# **Pacific Sardine STAR Panel Meeting Report**

NOAA / Southwest Fisheries Science Center  
La Jolla, California  
February 21-23, 2017

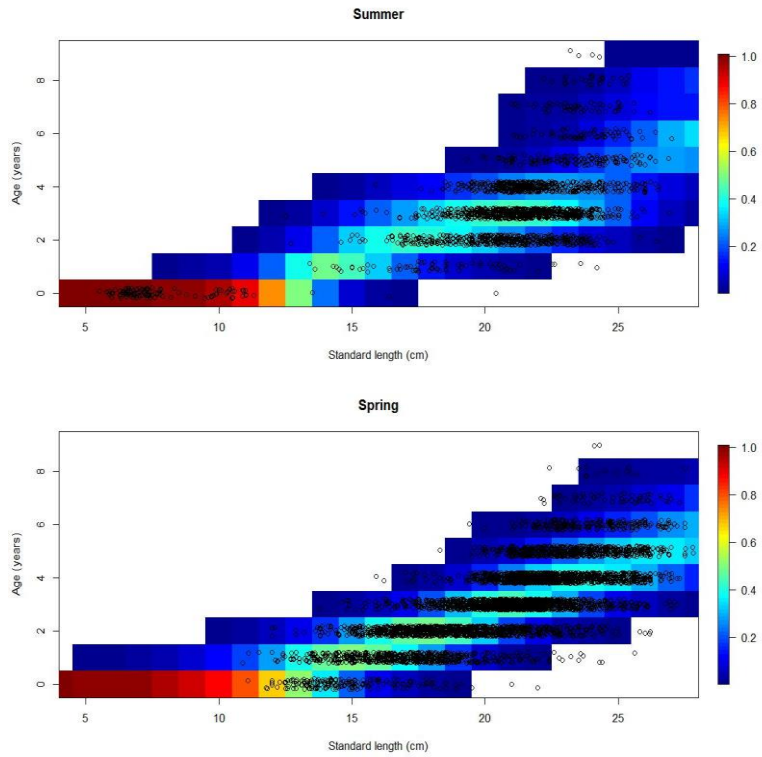
**Request 1:** Provide documentation on the procedures used to calculate the survey age-composition data, including how age-length and age-biomass keys are constructed.

**Rationale:** These calculations are critical to projecting biomass after accounting for natural mortality, somatic growth, and recruitment; but the draft assessment document did not describe these calculations in sufficient detail for them to be reproduced. In addition, the age-compositions for the ATM survey in model ALT were computed using the method.

The Panel agreed that aggregation across years is not appropriate if some length classes represent multiple ages, which is the case for Pacific sardine. Moreover, substantial spatial and temporal variation occurs in size-at-age, and merging the data from several years creates bias in annual estimates of age compositions of varying magnitude and direction.

**Response:** Dr. Zwolinski presented written documentation and figures. The function "multinom" from the R package "nnet" fits a multinomial log-linear model using neural networks. The response is a discrete probability distribution (see Fig. 1). It is simpler to use than the alternative (sequential logistic models), and it provides a smoother transition between classes than an empirical age-at-length key. The age and lengths used for constructing the age-length key were from surveys from 2004 to the present. Due to the assumption of a July first date and its effect on ageing, the STAT built a season-specific age-length key using data pooled across time, separately for spring/summer.

Fig. 2. Weight-at-age by cohort for the ATM survey.

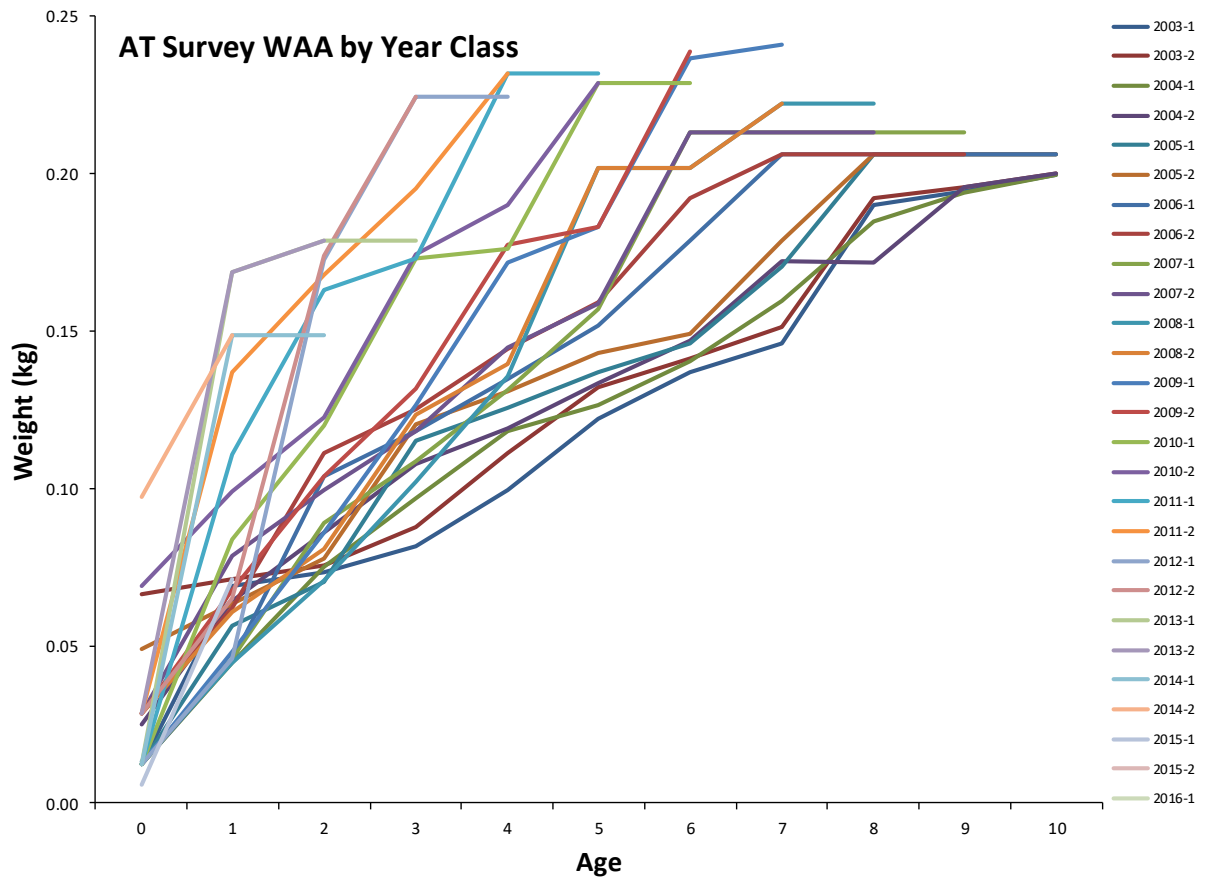
**Request 3:** Plot cohort-specific rather than year-specific growth curves (weight-at-age) for the ATM survey and overlay raw data/information on sample sizes. Make it clear which values are estimated versus inferred. Do this for the fisheries data as well.

**Rationale:** Cohort-specific curves are easier to interpret as growth trajectories than year-specific curves. It is important to understand how much data drives these estimates, and to understand the

consequences of applying the same age-length key for all years with survey data to calculate the weight-at-age and age-composition for the ATM survey.

**Response:** Dr. Hill presented tables including sample sizes and estimated means for each cohort-season-age combination. The tables were formatted to highlight entries that were inferred versus estimated. Dr. Hill calculated means whenever 3 or more samples were available. However, these means were sometimes overwritten based on the assumption that animals did not shrink. The ATM data showed substantial variation in weight-at-age across years (Fig. 2), and possibly increasing size-at-age in recent years. The MexCal catch data appeared less variable overall, and it was noted that fishery sample sizes were generally larger than the ATM sample sizes. The smoothing was not applied to the PNW catch.

The Panel noted that the adopted method ended up discarding data for cohorts with unusually large mean sizes for (for example) age-0 fish by not allowing "shrinkage", whereas it may have been the age-0 means that were anomalous rather than the means calculated for older ages. The Panel also noted that in many cases, the sample sizes were very small. The weight-at-age key used within the survey-based projection did not exclude "shrinkage". Using the weight-at-age key in model ALT produced an imperceptible difference in model-estimated age 1+ biomass.

Fig. 3. ATM survey selectivity for the spring and summer surveys from Model T2017 and a variant of that model in which the last two ATM length-compositions are dropped from the model.

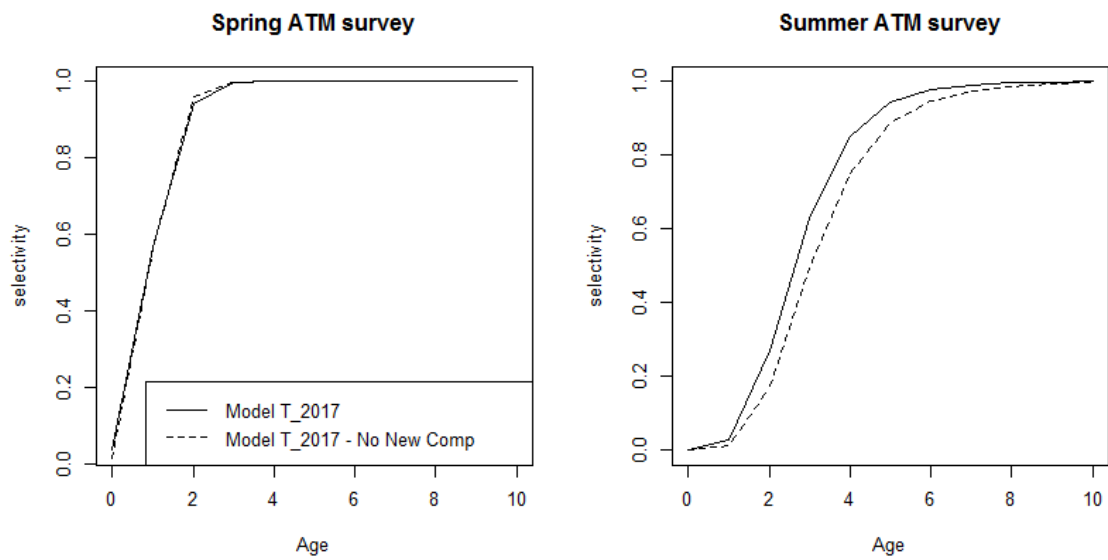
**Request 7:** Show more outputs from T\_2017 and T\_2017\_No\_New\_AT\_Comp.

**Rationale:** These outputs would help the Panel evaluate the reasons for proposing a move away from a strict update of the previously accepted model structure, i.e. identify problems with a strict update that the new model structure addresses.

**Response:** Selectivity curves for the spring and summer ATM surveys were noticeably different depending on whether the two most recent survey length-compositions were included in the assessment or not (Fig. 3). These models appeared to yield acceptable fits to abundance indices, but the fits to observed length-compositions were poor. It appears that the model estimates very low selectivity on small fish for the summer survey (since selectivity does not vary across years, and very few small fish are encountered most years) such that when small fish are encountered, they are expanded to a very large number. During Panel discussion, it was noted that this unexpected behavior should not happen if selectivity were forced to be the same for the spring and summer surveys.

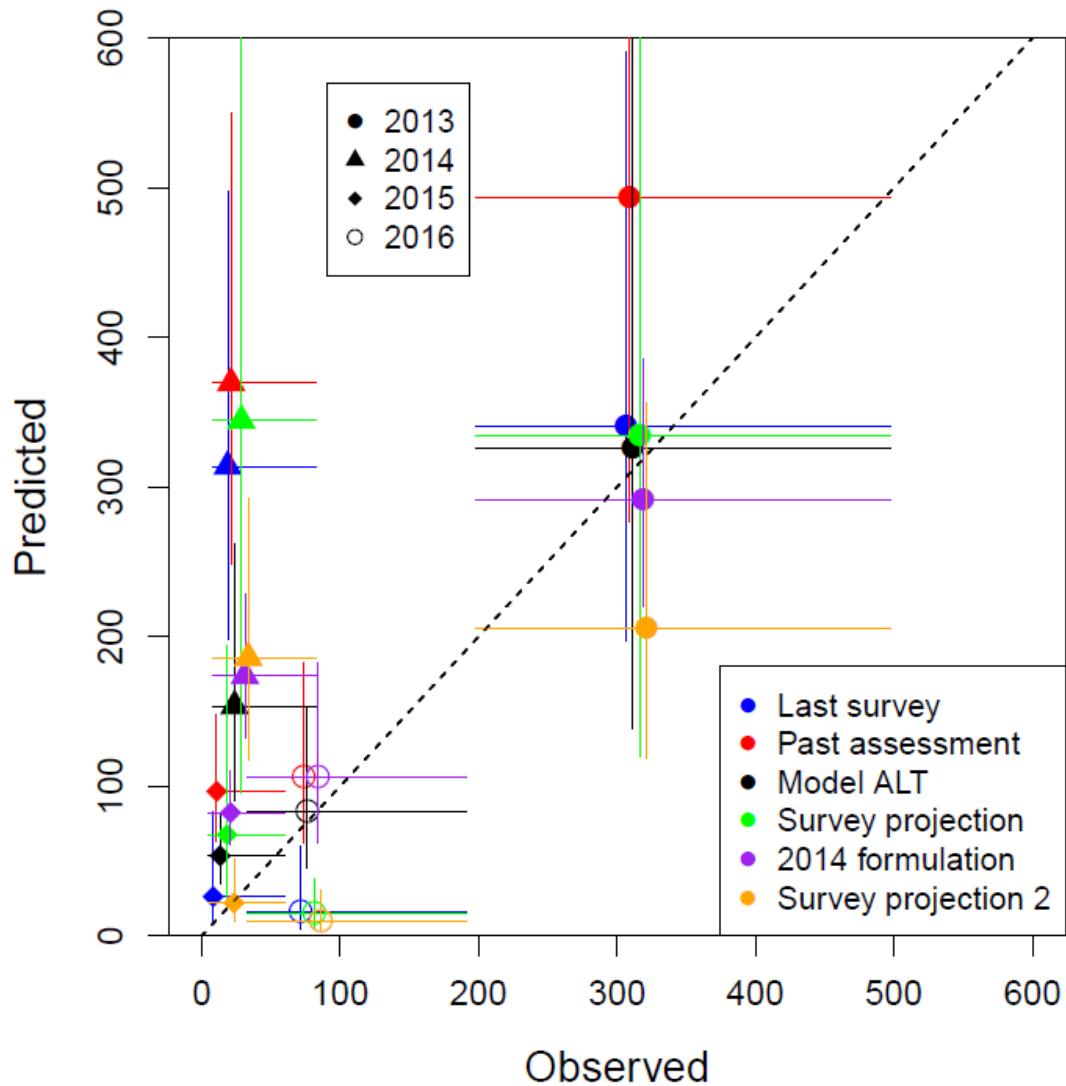
**Request 10:** Conduct a retrospective evaluation of how well alternative assessment methods can predict the biomass from the summer ATM surveys. For each year Y for which there is a summer ATM survey estimate for year Y and year Y+1, report predictions of year Y+1 biomass based on

(a) the estimate of biomass from the results of the ATM survey during summer of year Y, (b) the estimate of biomass based on applying the projection method to the results from the ATM survey in summer of year Y, and (c) model ALT based on data through year Y.

**Rationale:** The Panel wished to understand which method was able to predict the ATM survey estimate of biomass most accurately.

**Request 11:** Develop a method for estimating recruitment solely from ATM data, explain how these recruitment estimates could be used to project forward from an ATM biomass estimate, and then add results for that method to the retrospective comparison described in Request 10.

**Rationale:** During discussion of Request 10, it was clear that much of the concern regarding the currently proposed method of projecting from the survey was its dependence on model ALT for stock-recruitment estimates for conducting the projection, resulting in its dependence on the same assumptions the STAT was hoping to avoid by moving away from an integrated assessment. It was pointed out that it could be possible to develop estimates of age 1 biomass on 1 July, 2017 strictly from the ATM data.

**Response:** The STAT provided results for the three selected approaches as well estimates of age 1+ biomass obtained by projecting the actual assessments used for 2012, 2013, 2014 and 2015 forward (“Past assessment” in Fig. 4) and estimates of age 1+ biomass obtained by projecting the model used for 2014, 2015 and 2016 management advice (“2014 formulation”). Model ALT generally came closest to predicting the survey biomass estimate the following year, doing so by a substantial margin for 2014. “Past assessment” was usually the worst. Model ALT had the lowest residual variance. Relative errors were a CV of 1.07 for Model ALT, 1.26 for the 2014 model formulation, 1.50 for the last survey without projection, 1.62 for the values adopted in management specifications, and 1.70 for projections from the previous ATM survey (see Appendix 2 for the specifications for the method).

**Response:** The STAT modified the survey projection method so that projected biomass of 1-year-olds was the average over the most recent five years (see Appendix 2 for details). As desired, this approach was not tied to the model ALT. However, the residual standard deviation for this approach (“Survey projection 2”), while better than “Survey projection”, was still worse than Model ALT and the 2014 model formulation (1.45) (Fig. 4).
